**AGENDA
CITY OF HARRISONVILLE
PLANNING & ZONING COMMISSION
REGULAR MEETING
CITY HALL
JANUARY 18, 2024
6:00 PM**

TO: Planning & Zoning Commission
FROM: Christina Stanton,
DATE: January 11, 2024
SUBJECT: Appl. #PREDEV-23-002--PRELIM. DEVEL. PLAN for iFIL Expansion on property located at 1801 W. Vine St.

Re: Appl. #PREDEV-23-002 – PRELIM. DEVEL. PLAN for iFIL Expansion on property located at 1801 W. Vine Street

OVERALL SITE PLAN

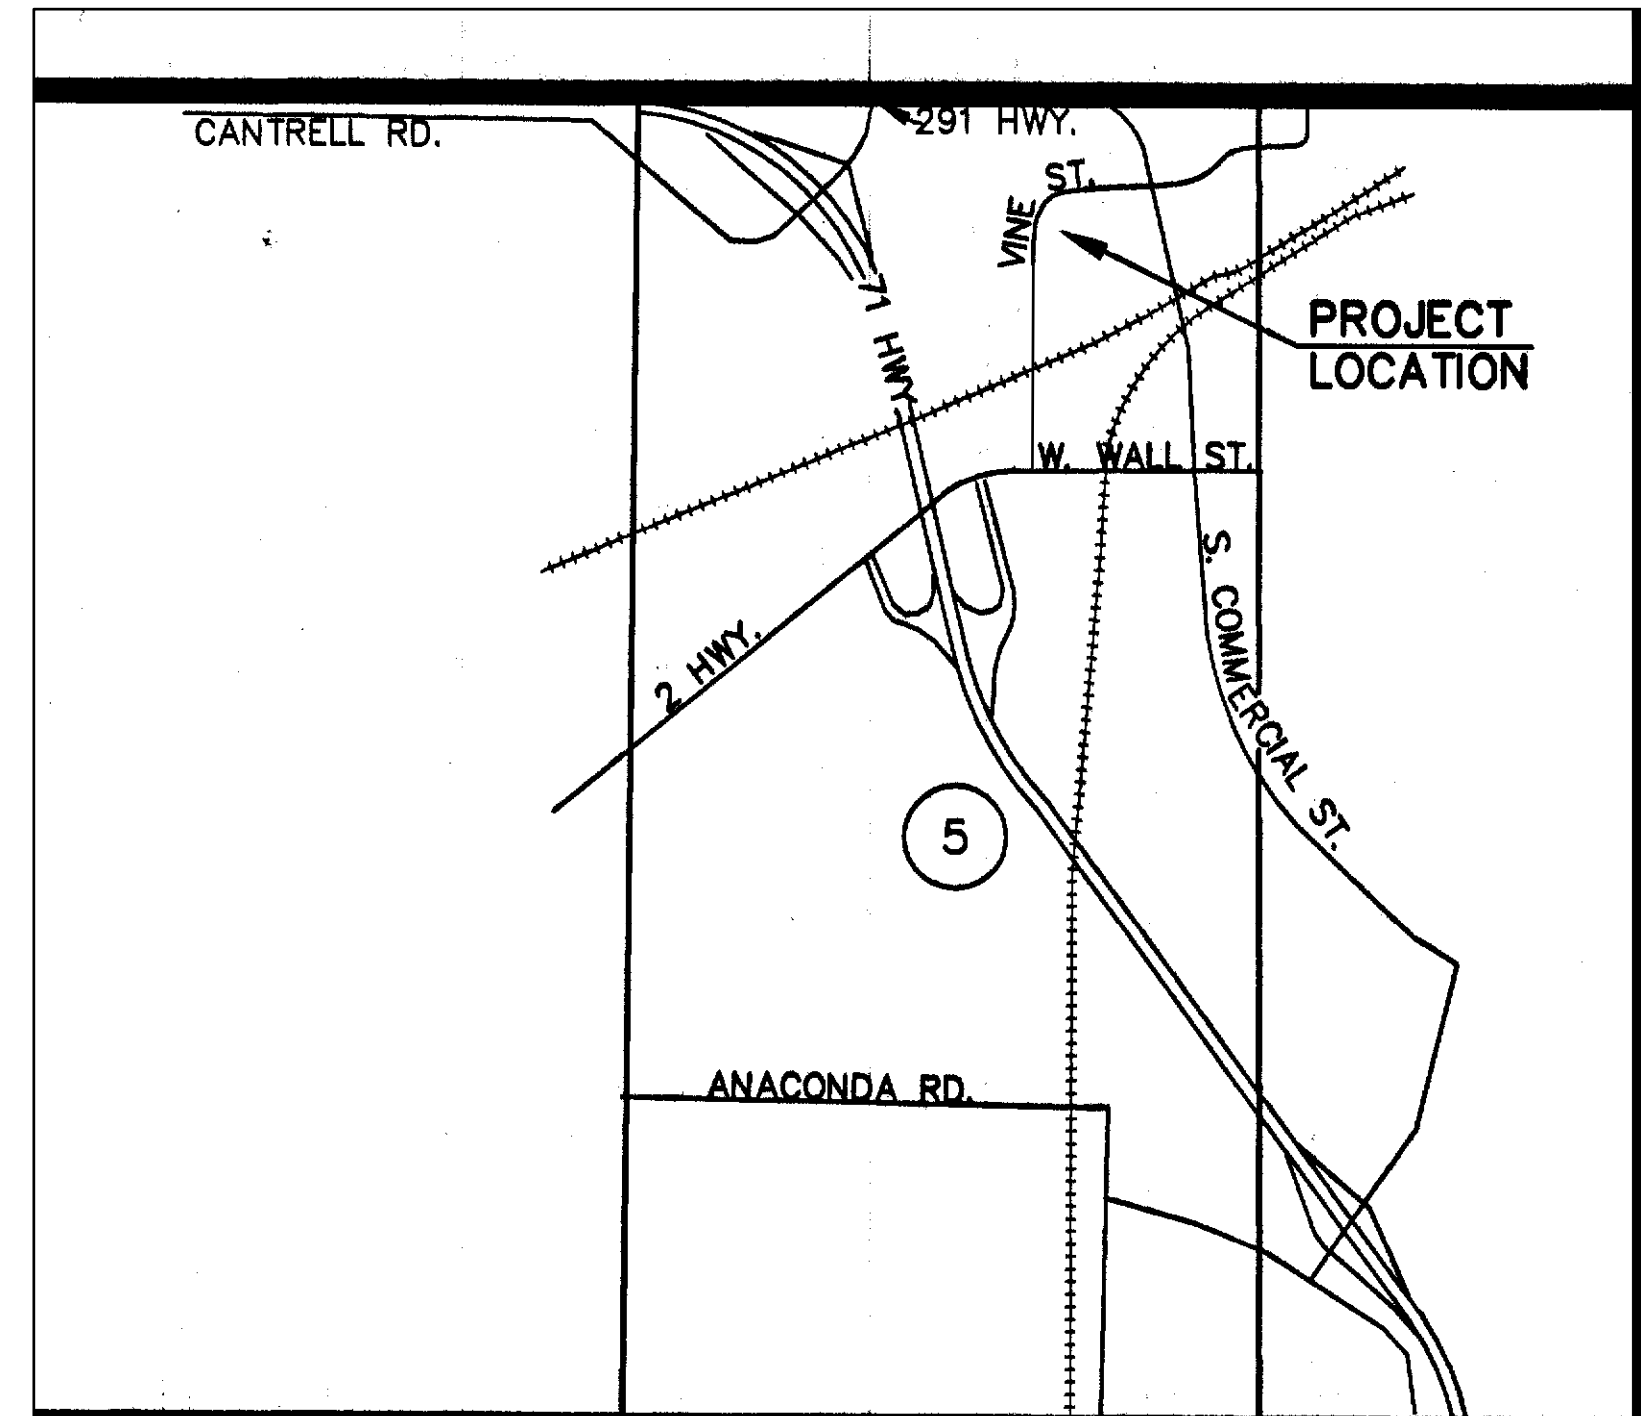
The proposed addition meets all the setback requirements, and the building height is less than the maximum height allowed. However, the lot coverage requirement is slightly exceeded as the total percentage of lot coverage (building coverage + pavement coverage) is 60.98%. The applicant has identified that Section 405.495.A.5 states “The building coverage shall not exceed sixty percent (60%)”, which it does not, however, Appendix B: Dimensional Standards Table that was adopted in February of 2023 states “Lot Coverage” so there is a slight contradiction between the two that staff will need to rectify in the near future.

Parking. Section 405.565.E, the Minimum Parking Required by Use Table, of the City's Municipal Code requires one (1) parking spaces for each one thousand (1,000) square feet of gross floor area for manufacturing/warehouse uses and four (4) spaces for each one thousand (1,000) square feet of office space. If it were assumed that the facility was 100% manufacturing/warehouse the required parking would be $70,375/1,000 = 70.375$ or 71 spaces. This is not the case.

However, the Preliminary Development Plan indicates that the maximum number of employees per shift is 40 and calculates a 150% “shift change-over overlap” for a total of 60 employees on site at any given time. Based on this data there are an adequate number of parking spaces (35 existing + 36 proposed = 71 total parking spaces).

- 1) The proposed pavement on the site shall be reduced slightly so that the maximum lot coverage requirement is not exceeded.
